CUSTOMER SATISFACTION CAMPAIGN 2A91 GSX-R1000RA/RZAL7-L8 Inertial Sensor Replacement

Affected Models: 2017 - 2018 GSX-R1000R/RZ

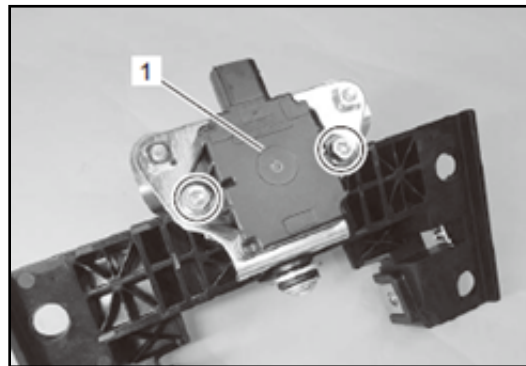
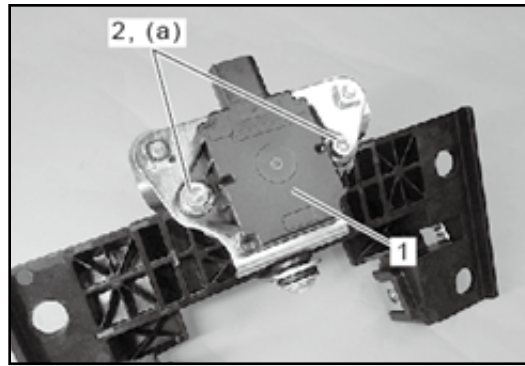
- 15) Remove the IMU (1) from the fuel tank rear bracket.

- 16) Install the countermeasure IMU (1) and tighten the IMU bolts to the specified torque.

Tightening torque

IMU bolt (a):

8 N·m (0.8 kgf-m, 5.9 lbf-ft)
